PUERTO VERDE

Green Eagle Railroad US Alignment

May 25, 2024

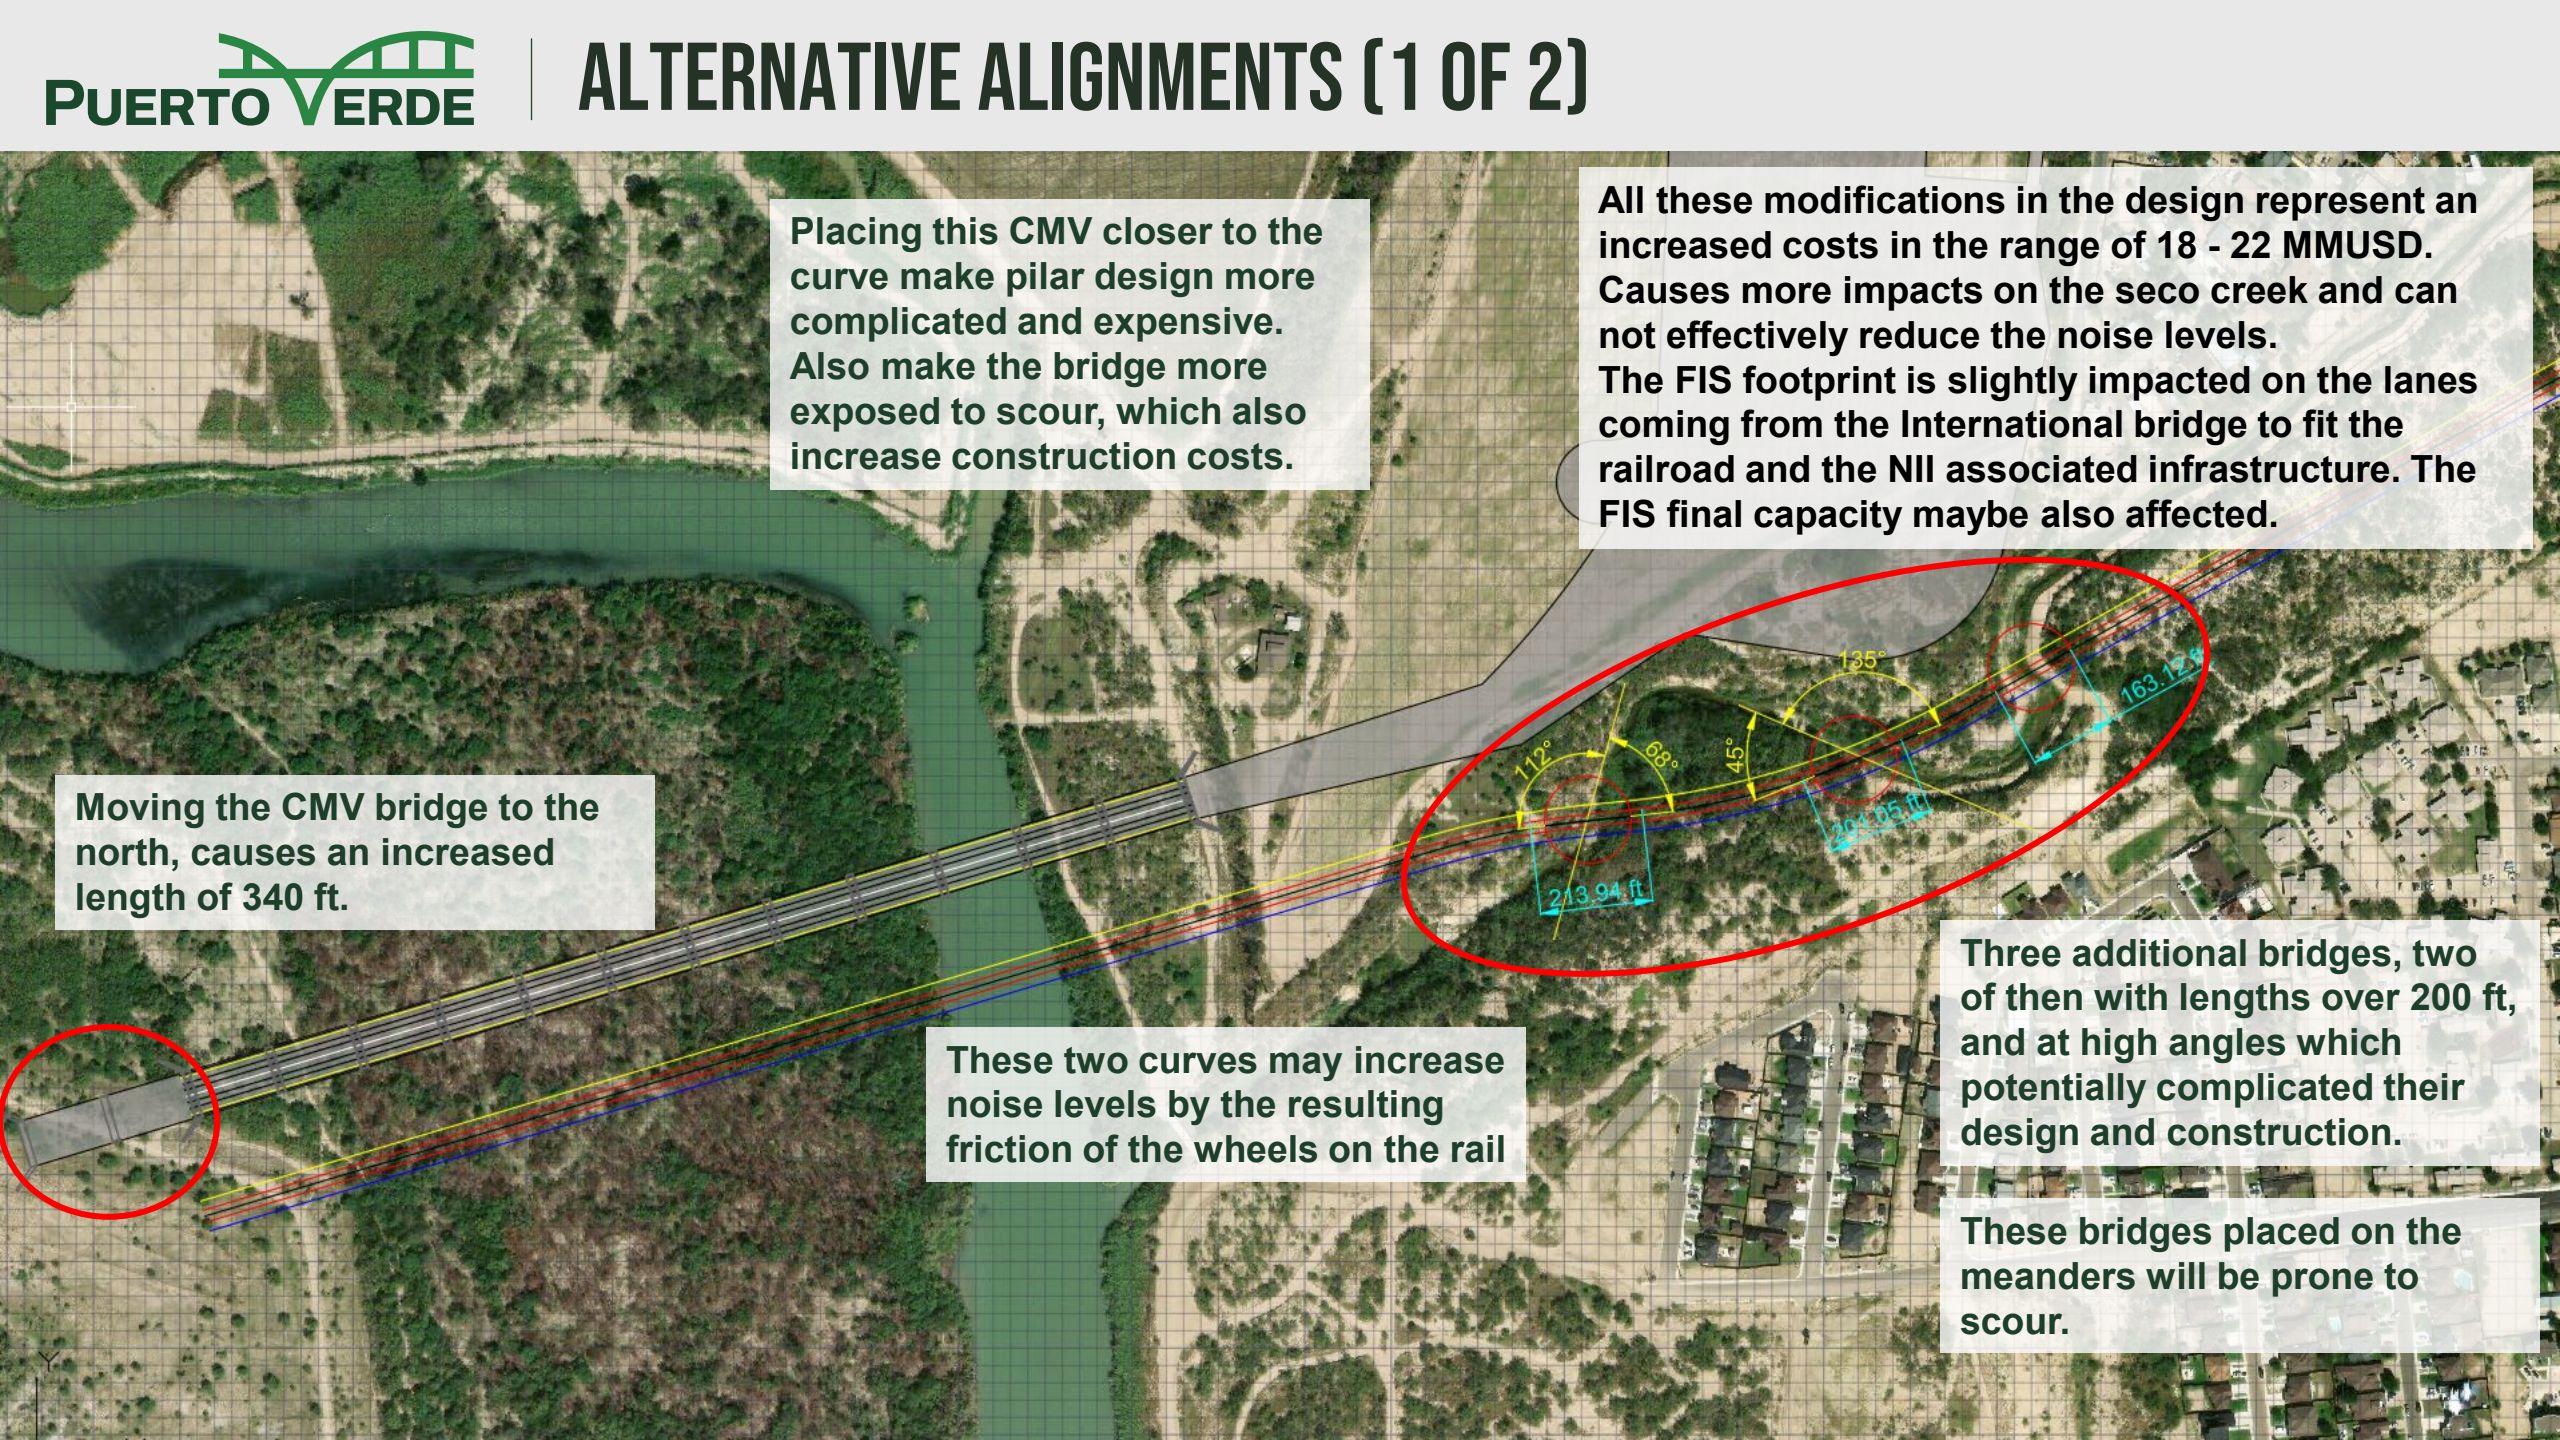
Placing this CMV closer to the curve make pillar design more complicated and expensive. Also make the bridge more exposed to scour, which also increase construction costs.

All these modifications in the design represent an increased costs in the range of 18 - 22 MMUSD. Causes more impacts on the seco creek and can not effectively reduce the noise levels. The FIS footprint is slightly impacted on the lanes coming from the International bridge to fit the railroad and the NII associated infrastructure. The FIS final capacity maybe also affected.

Moving the CMV bridge to the north, causes an increased length of 340 ft.

These two curves may increase noise levels by the resulting friction of the wheels on the rail

Three additional bridges, two of then with lengths over 200 ft, and at high angles which potentially complicated their design and construction.

These bridges placed on the meanders will be prone to scour.

Current alignment design is the most respectful with both the Seco Creek and the surrounding urban areas.

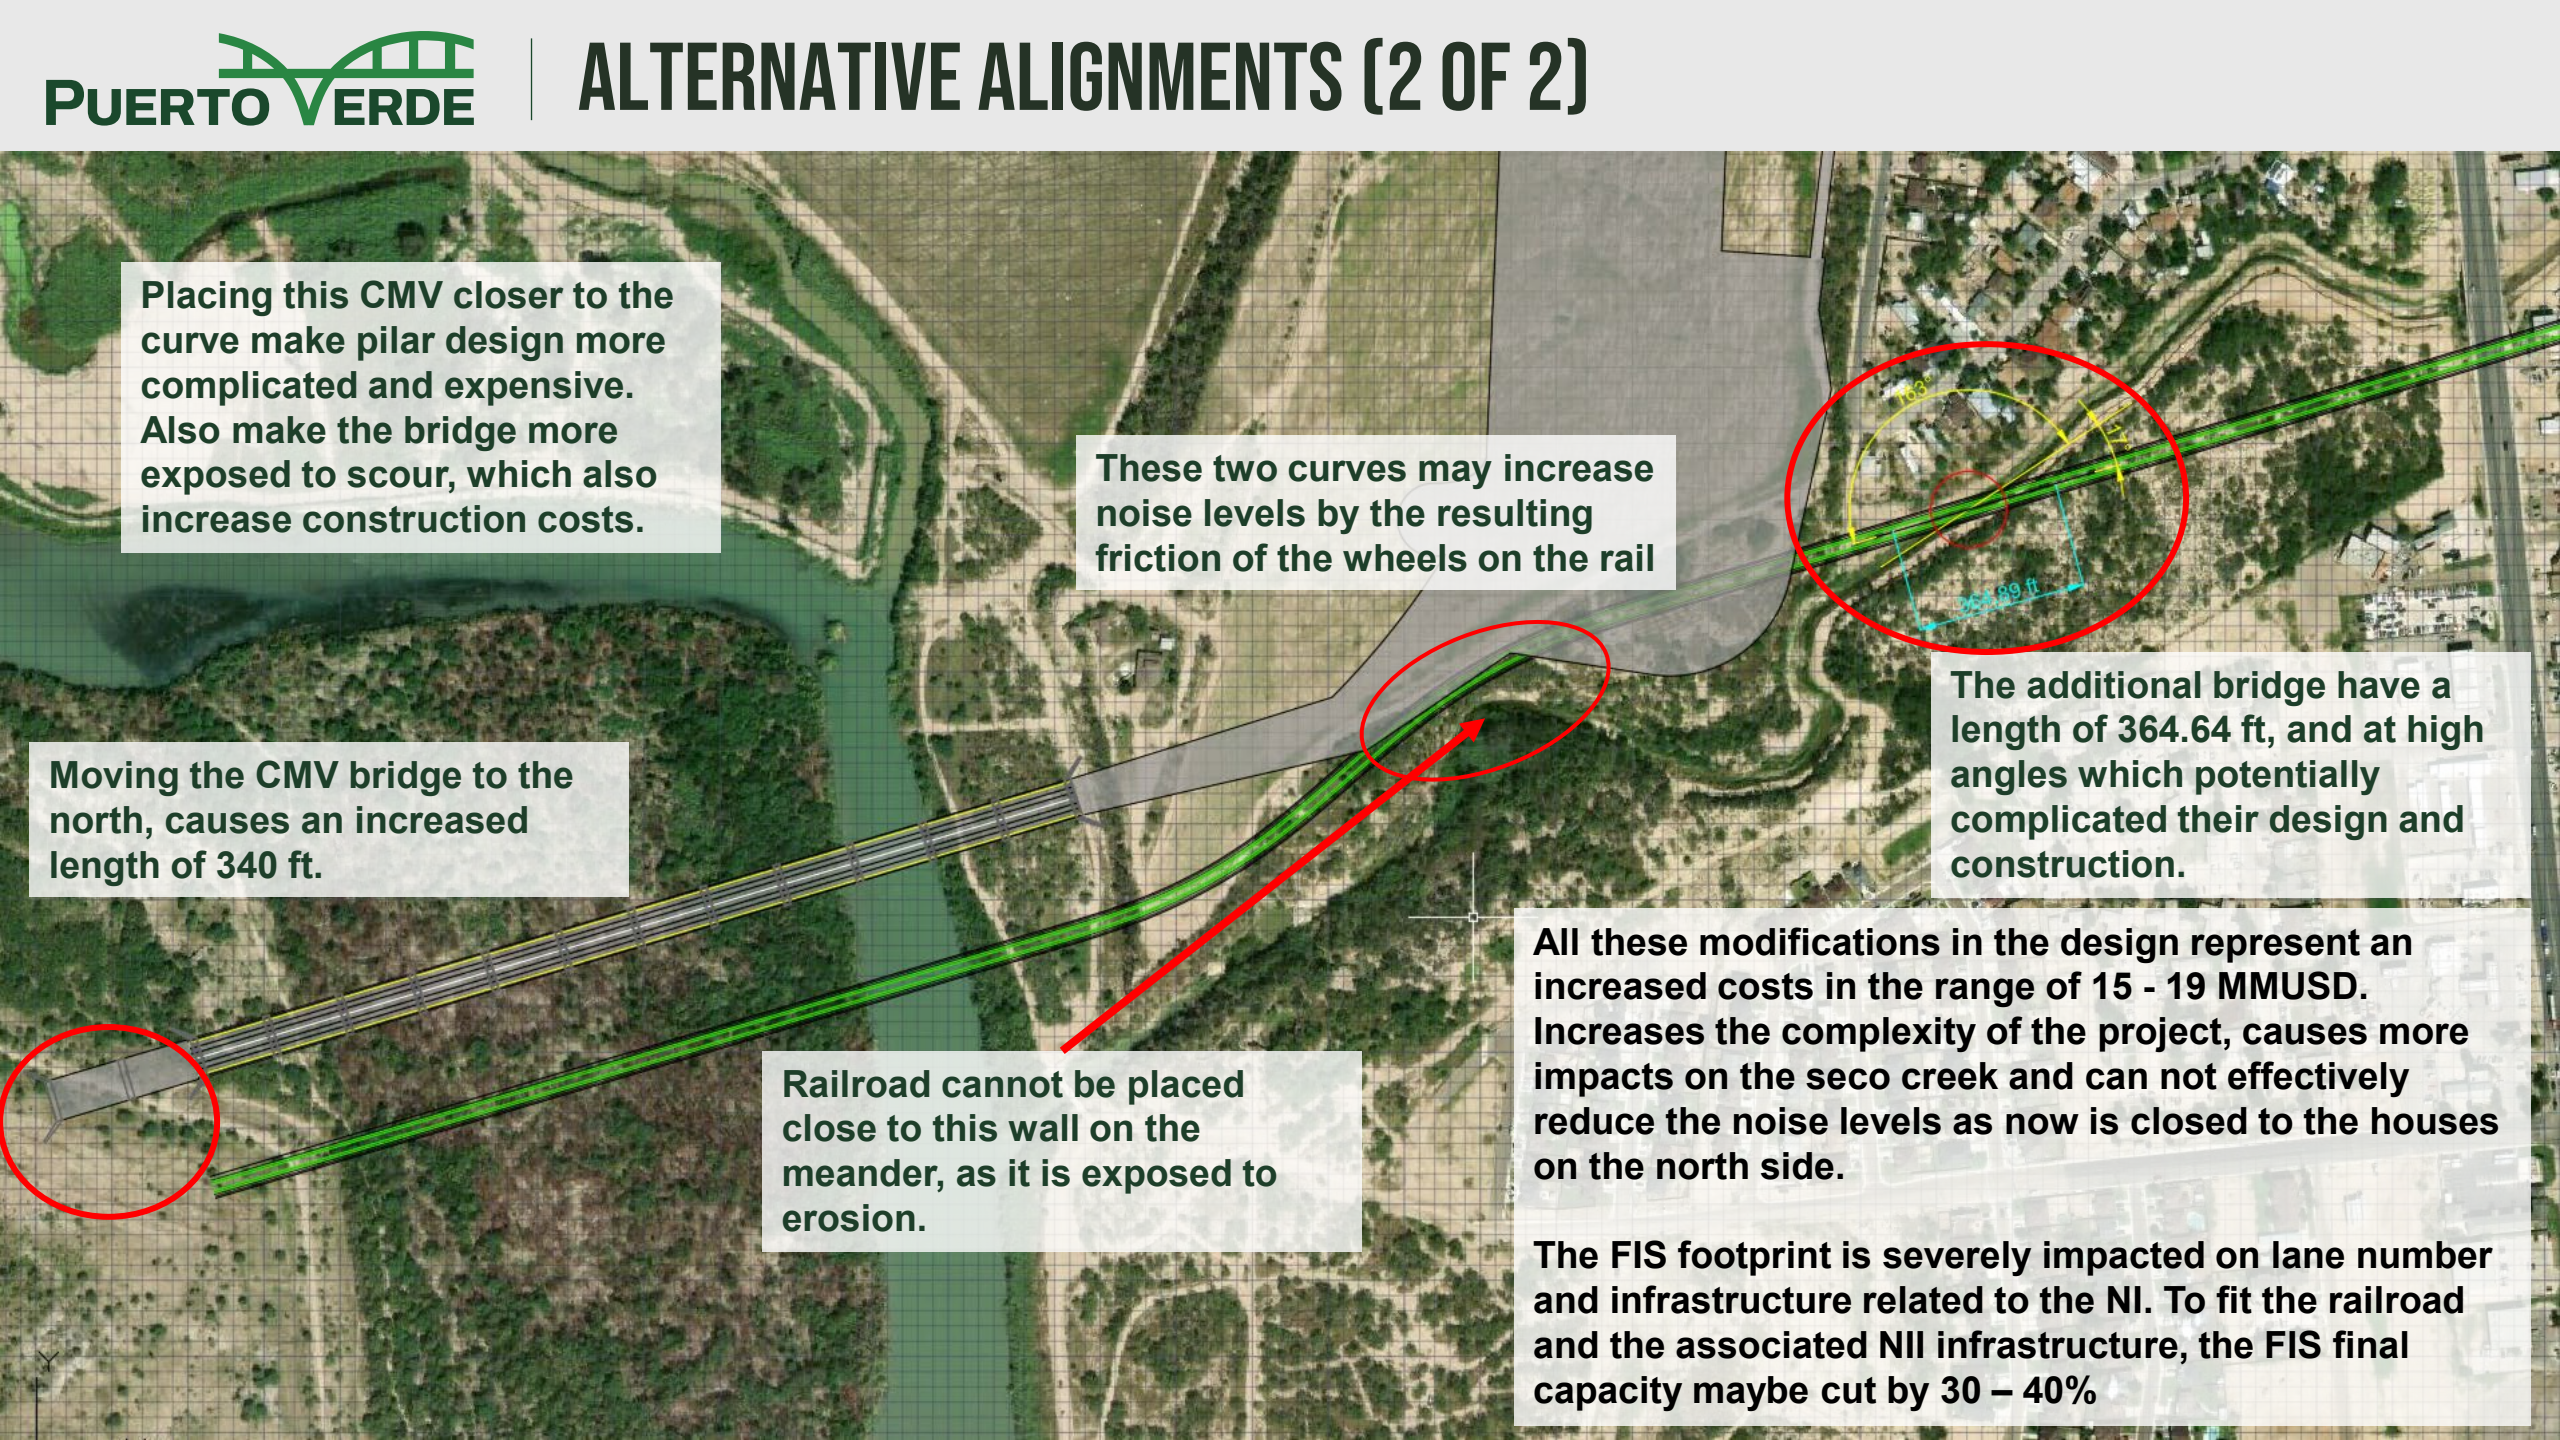
Placing this CMV closer to the curve make pillar design more complicated and expensive. Also make the bridge more exposed to scour, which also increase construction costs.

These two curves may increase noise levels by the resulting friction of the wheels on the rail

The additional bridge have a length of 364.64 ft, and at high angles which potentially complicated their design and construction.

Moving the CMV bridge to the north, causes an increased length of 340 ft.

Railroad cannot be placed close to this wall on the meander, as it is exposed to erosion.

All these modifications in the design represent an increased costs in the range of 15 - 19 MMUSD. Increases the complexity of the project, causes more impacts on the seco creek and can not effectively reduce the noise levels as now is closed to the houses on the north side.

The FIS footprint is severely impacted on lane number and infrastructure related to the NI. To fit the railroad and the associated NII infrastructure, the FIS final capacity maybe cut by 30 – 40%
